Ship's Name S/s "EMPIRE CENTAUR" (Wm Gray & Co. 1134) Official No. 168946.

Memorandum of alterations reported since ship was surveyed for assignment of Load Lines
in August 1942

alterations

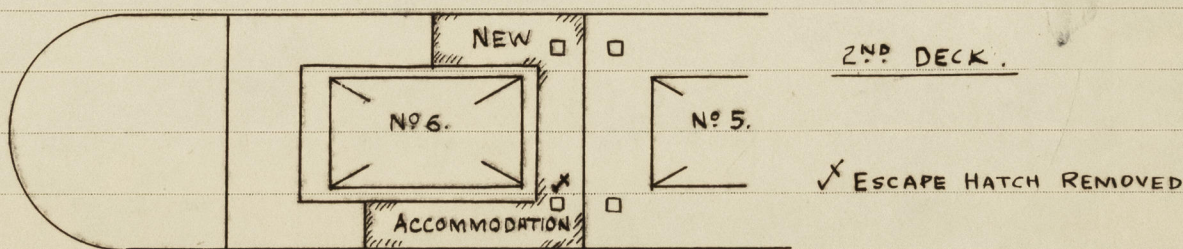
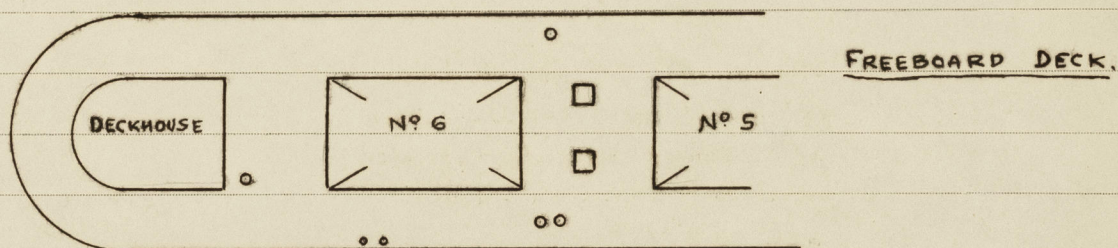
- 1/ The following alterations have been made to suit additional accommodation for gunners in No. 6 'tween deck.
- 2/ Additional sidelights with efficient deadlights have been fitted in the shell plating (P&S) in way of No. 6 'tween deck.
The sill of the lowest sidelight is 34'-0" above the base.

- 3/ Two additional brass non-return valves now fitted in starboard side of shell from soil and shower bath discharges. Valves geared to freeboard deck.

- 4/ Wood covers 2½" thick fitted to Nos. 1 & 6 'tween deck hatchways i.e. all 'tween deck hatchways are now fitted with wood covers.
- 5/ One small escape hatch at fore end of No 6 'tween deck (stbd) has been removed and deck plated over.

- 6/ Four additional 8" vents have been fitted on freeboard deck in way of No. 6 hatch with coamings 36" x 30"
- 7/ Two additional 6" gooseneck vents have been fitted on freeboard deck at stbd. side in way of No 6 hatch. Vents 18" high.

- 8/ All additional vents are fitted with closing appliances.
